PATENT
Attorney Docket No. 021619.0106

MARKED-UP COPY OF AMENDMENTS TO THE CLAIMS AND DRAWINGS

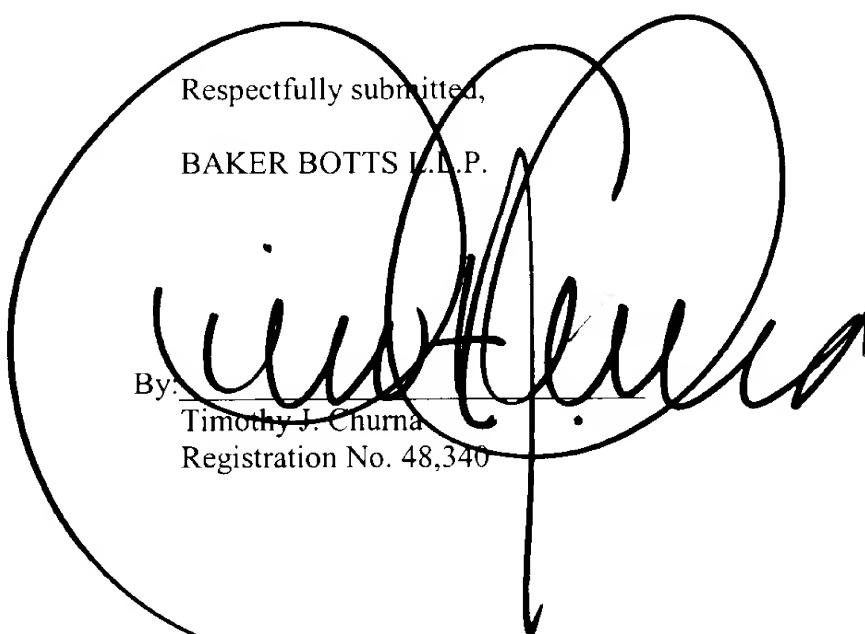
The drawings stand objected to as allegedly failing to include a reference numeral 80 for the “common center element” as set forth on page 10 of the above-referenced patent application. Applicants have amended original **Fig. 5** in order to include reference numeral 80 for the common center element. Therefore, Applicants respectfully request that the Examiner withdraw the objection to the drawings.

Please replace original **Fig. 5** with replacement **Fig. 5**. Applicants are including replacement **Figs. 4 and 5** (**Figs. 4 and 5** originally were submitted on the same page) with this responsive amendment. For the Examiner's convenience, Applicants also are including a marked-up copy of **Fig. 5**, with the changes marked in red ink, with this responsive amendment.
